# PROPOSED CHANGE ORDER

SR 10/US 278 FM CS 721/ASHTON PLACE TO

37

Reference: PI# 0015071 – SR 10/US 278 FM CS 721/Ashton Place to Sams Street  
Pavement Patching/Overlay

Figure 1. DeKalb County Standard Detail - Typical Asphalt Pavement Patch

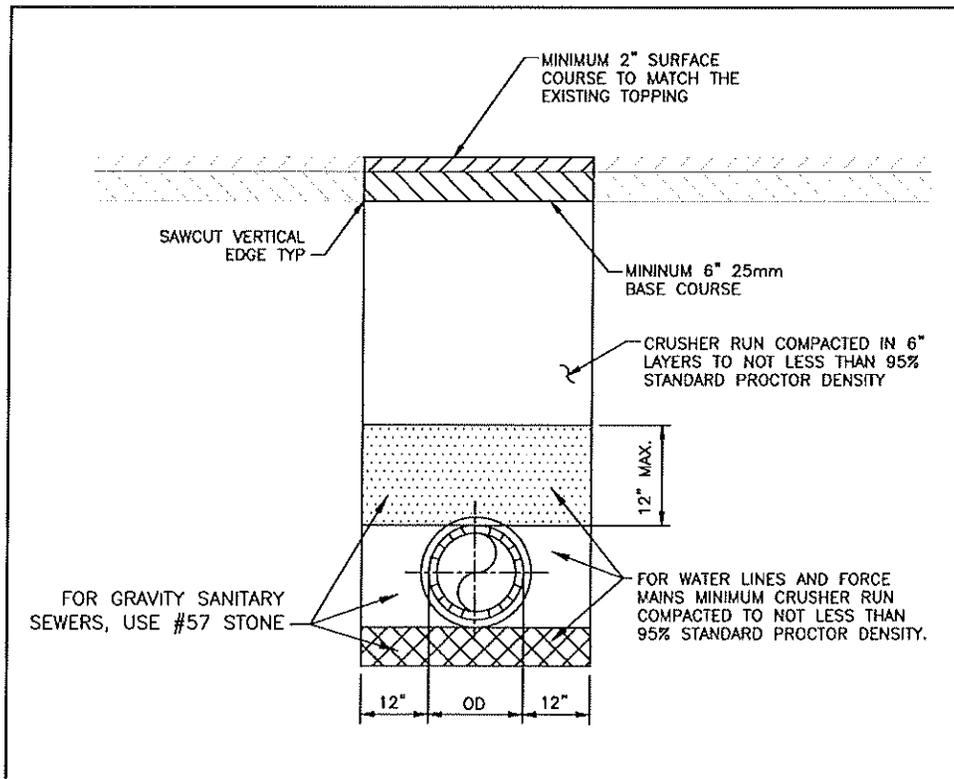
I conducted a site visit on November 5, 2025, to assess the quality of the asphalt pavement patch installed by DeKalb County as part of their utility work along the project. The patching detail used for the roadway patch was a DeKalb County Standard Detail (See Figure 1).

Based on the Pavement Evaluation Report prepared by Geo-Hydro Engineers, dated November 3, 2025, there are locations where the pavement patch has some "soft" spots due to poor subgrades. Two locations were identified for core sampling (See Figures 2 and 3). Based on the samples, the patches include approximately 8 inches of asphalt atop poor subgrade material.

Ideally, the patch would have been installed per GDOT Standard Detail (Std. Det.) 1401. (Note: DeKalb County Standard Detail - Typical Patch and Resurfacing Detail satisfies the minimum requirements of GDOT Std. Det. 1401, so it also would have been an acceptable alternative.) However, it is not cost effective, nor is there enough time, to remove the existing asphalt patch and replace it with the preferred patch prior to installing the asphalt overlay this paving season.

Figure 4. Limits of Deep Patch

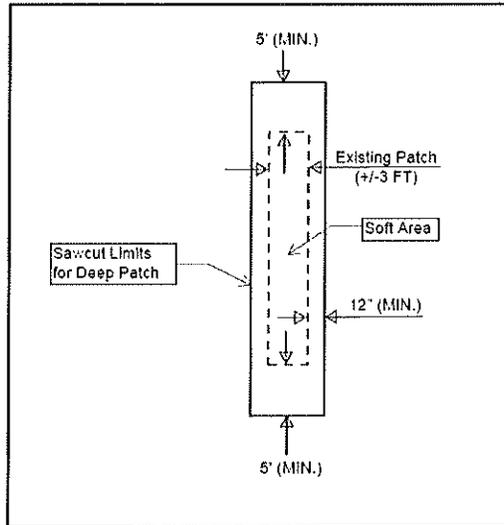
In my opinion, the patch is satisfactory for most of the corridor. Much of the patch will be in the new median area when the project is complete, so it will not experience load stresses that the travel lanes will experience. A cost-effective solution is to install pavement reinforcing fabric over the joints for the length of the project. There are spots where I recommend removing and replacing the patch with a GDOT Std. Det. 1401 patch. However, due to traffic control, I would recommend high early strength concrete (3000 psi minimum) instead of Class B concrete. Order of operations for the remaining pavement work would be

1. Mill the existing pavement, including patch, 1.5 inches.
2. Sawcut the "soft" patch area ensuring the sawcut is a minimum of 12 inches wider than the patch on each side and five feet longer on each end of the perceived "soft" patch area. Remove existing asphalt and replace it with high early strength concrete (3000 psi minimum). Concrete shall be at least 8 inches thick. Finished grade shall be flush with milled asphalt surface. Use GDOT Pay Item 500-0600 Twenty-Four Hour Accelerated Strength Concrete. I estimate 30 cubic yards of concrete will be required for the entire project.
